Access Compliance Report Public Rights-of-Way (Curb Ramps)

Main Street: CALVO_DR Cross Street: ETHELBEE_WAY Location: NW

ADA ID: RPAT210930084411 Ramp Type: Type 1 - Perpendicular Diagonal Initial Pass/Fail: Pass Overall Compliance: No Severity Score: 22

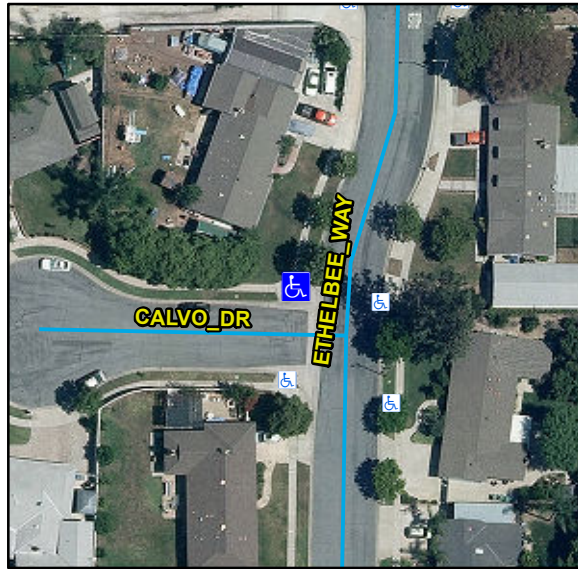
Compliance	Description	Data	Compliance	Description	Data
N/A	Ramp Length (in)	118	N/A	Flare Type LT	
Yes	Ramp Width (in)	79			Sloped
Yes	Ramp Run Slope (%)	7.5	N/A	Flare Slope LT (%)	6.2
Yes	Ramp Cross Slope (%)	1	N/A	Flare Traversable LT	No
N/A	Landing Present	No	N/A	Flare Type RT	
N/A	Landing Length (in)	N/A			Sloped
No	Landing Width (in)	N/A	N/A	Flare Slope RT (%)	5.4
No	Landing Run Slope (%)	N/A	N/A	Flare Traversable RT	No
No	Landing Cross Slope (%)	N/A	No	DWS Provided	No
N/A	Landing Movement Obstructed?	No	N/A	DWS Contrast	N/A
	Landing Movement Type	N/A	N/A	DWS Length (in)	N/A
N/A	Landing Shared	N/A	N/A	DWS Full Width	N/A
N/A	Clear Space	Yes	N/A	DWS Offset Left (in)	N/A
N/A	Clear Space To Crosswalk (in)	48	N/A	DWS Offset Right (in)	N/A
N/A	Marked Crosswalk 1	No	N/A	Marked Crosswalk 2	No
	Crossing 1 Direction	S		Crossing 2 Direction	E
	Marked Crosswalk 1 Width (in)	N/A		Marked Crosswalk 2 Width (in)	N/A

Remove & Replace Curb Ramp With Two New Directional Ramps or Equivalent.
